November 6, 2023
Ref: #11530

Reference: Conditional Use Sketch Plan Review; 53 Lot Development with On-Lot Sewer
Artisan Construction Group LLC (Benson Tract/Bechtel Farm at Stony Run)
446 Stony Run Road, UPI Nos. 21-5-79 and 21-5-78

As per your request, we have performed a cursory review of the Conditional Use Sketch Plan submission pertaining to the proposed subdivision and thereby offer the following comments for consideration by Township Officials:

TYPICAL CROSS-SECTION OF LOCAL RESIDENTIAL STREET

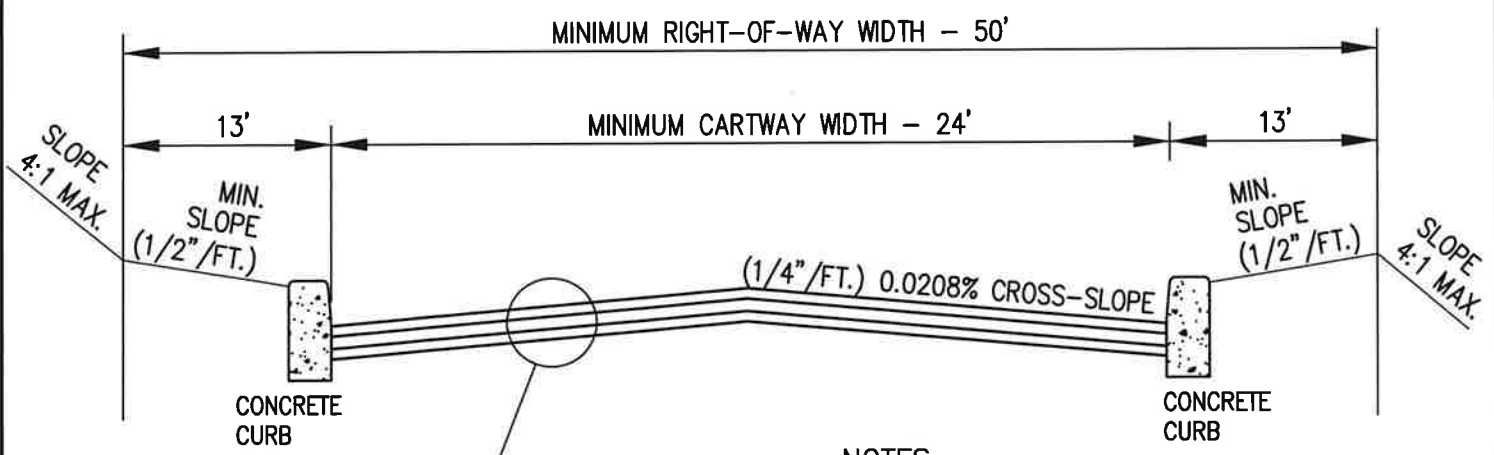
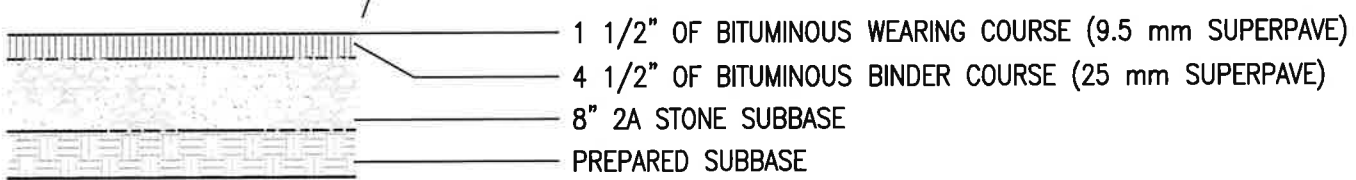
8. The minimum cartway width for local streets is 20 feet, which has been proposed. Additional cartway width may be required by the Township for public safety and convenience. We note that the Township recently proposed a standard detail for local residential streets, attached, that depicts a minimum 24 foot wide cartway with 4 foot wide sidewalks. (SLDO Sections 22-406.1 and 22-406.2.A)
